<b>Topic</b>	Bentayga - Front Lower Grille Replacement (SC16/35)
<b>Market area</b>	Bentley: worldwide (2WBE),Hongkong-Macau (5HK)
<b>Brand</b>	Bentley
<b>Transaction No.</b>	2045782/2
<b>Campaign number</b>	EA73
<b>Note</b>	
<b>Type</b>	Workshop Campaign
<b>US code</b>

On a small number of Vehicles front bumper grilles have been modified to prevent false obstacle warnings from the Park Distance Control (PDC) system, there is a possibility that the chrome effect finish may have been damaged during modification, this may lead to corrosion in the surrounding area.

Figure 1.

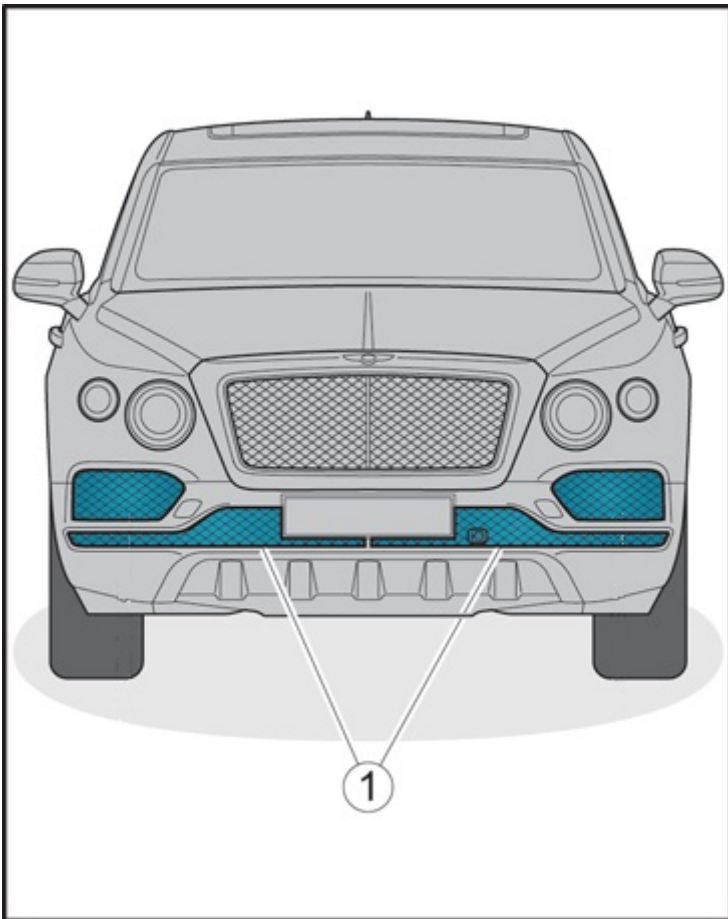
Replace the two lower front Grilles – figure 1.

Replace lower front Grilles – item 1 - with new parts – Refer to Repair Group 63 *Front Bumper Grilles – To Remove and Fit* – figure 1.
